**SUBDIVISION COMMITTEE
METROPOLITAN AREA PLANNING COMMISSION**

STAFF REPORT
(Final Plat)

CASE NUMBER: S/D 91-10 - MARSHALL MEARS ADDITION

STAFF REPORT

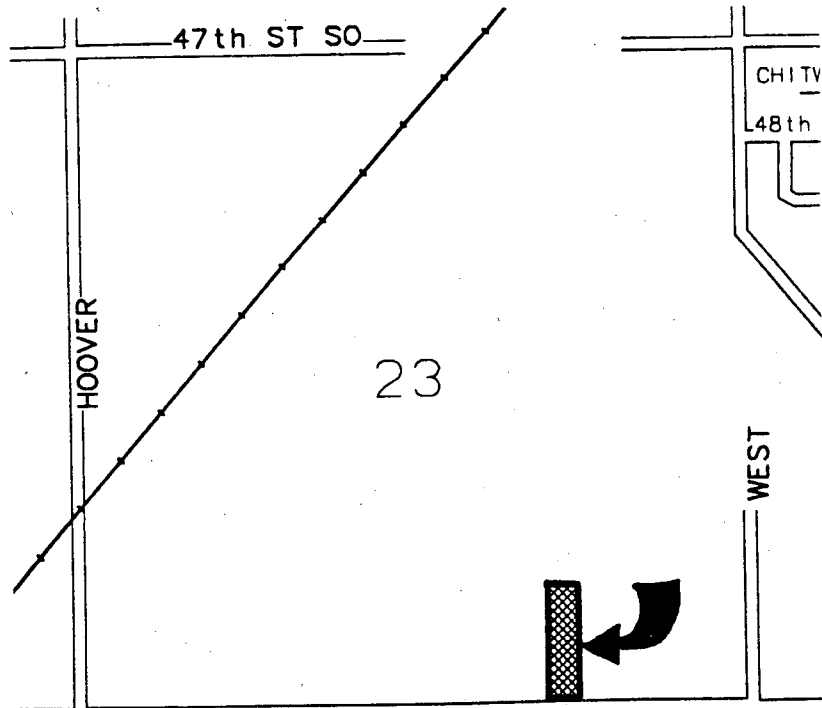
- A. Under R-1 County Zoning, a minimum lot frontage of 100-feet is required. As indicated by the plat, lot 3 will only have a 30-foot frontage. For purposes of emergency access, such a long (410-foot) private type drive is also unacceptable. Consequently, the platting of Lot 3 cannot be supported or only allowed with certain conditions. One of the following options should therefore be required.

1. Plat only two lots, with lot 3 included as part of lot 2 or lot 1. At such time as public access is provided to the area of lot 3, a lot split could be obtained by the applicant.

2. Require the applicant to dedicate from this site street right-of-way, while also obtaining sufficient right-of-way off-site, to provide the standard 70-foot of suburban street right-of-way. A guarantee for a residential street to the suburban street standard would be required.

3. Provide a contingent dedication of 35-feet of right-of-way along the east line of lots 1 and 3 for a future street extension and a covenant that restricts the development of this lot until a full public street is dedicated and installed. This covenant should clearly indicate that any such street needs to be to County standards and accepted by the County.

- D. On the final plat tracing, if a street dedication is provided along the east line of lot 1 (outright or contingent), appropriate building setbacks to such street shall be indicated. A 15-foot sideyard side back would be needed along lot 1 and at least a 25-foot front yard setback from lot 3 to any such road or cul-de-sac.

- E. As necessary, the 20-foot utility easement along the east line of lot 1 shall be adjusted for any street dedication in this area.
